THE CITY OF SAN DIEGO

Subject: Bacteria-1 and Chollas Creek Dissolved Metals TMDLs

Storm Water Pollution Prevention Program

## Canyon Mouth Option

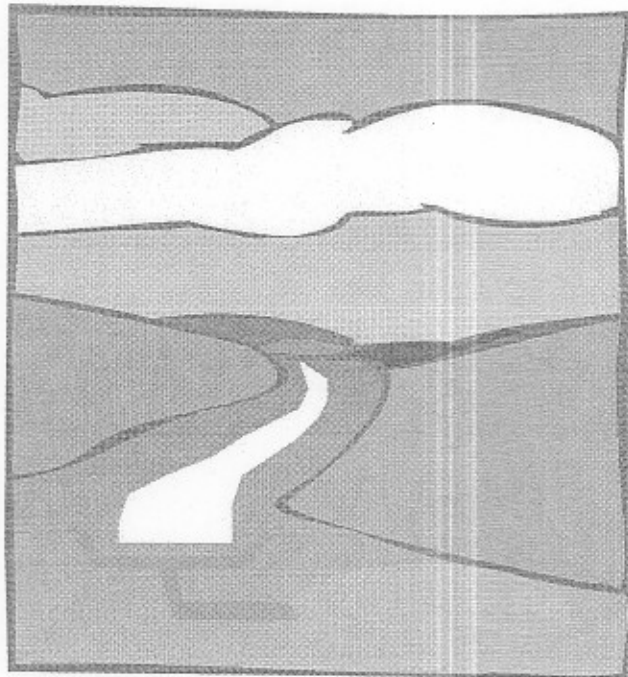
I have recently been invited by Regional Board staff to submit a proposal for what kind of BMP the City would like to build below outfalls. In response, I submitted the attached graphics and was told by Regional Board staff that these proposals were, in concept, acceptable, at least in terms of allowing receiving waters/Waters of the State to convey waste and in terms of achieving Wasteload Allocations below storm drain outfalls and still complying with the TMDLs. Please acknowledge that these solutions are conceptually acceptable. Based on a quick analysis, these solutions might be available for approximately 480 of the 800 outfalls within Chollas Creek.

- In this example, runoff is captured by a headwall and piped to a subsurface infiltration pit.
- The gold area represents the footprint of the pit; located to avoid impacts to receiving waters and sewer lines.
- Water upstream of the headwall may convey waste and may not meet the WLAs

## Base of Canyon Wall Option

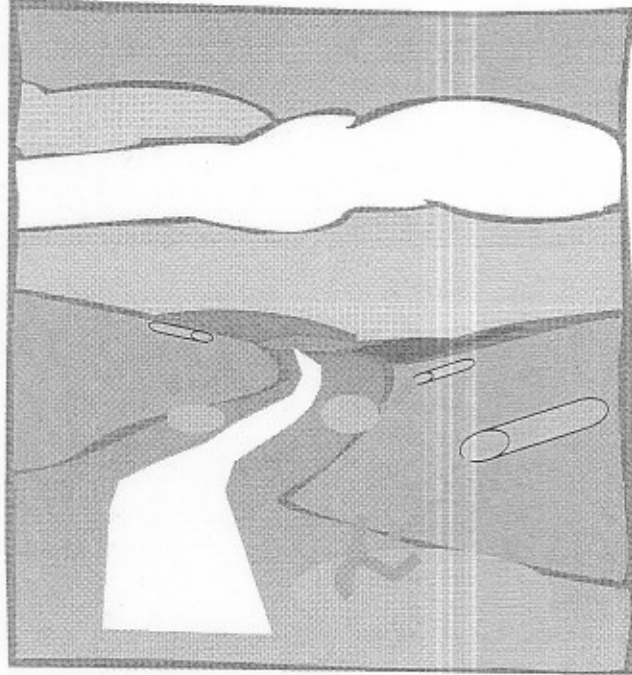
- In this example, runoff is intercepted at the base of the canyon wall, below the storm drain outfall but before it reaches the main channel in the canyon.

Water upstream of the headwall may convey waste and may not meet the WLAs
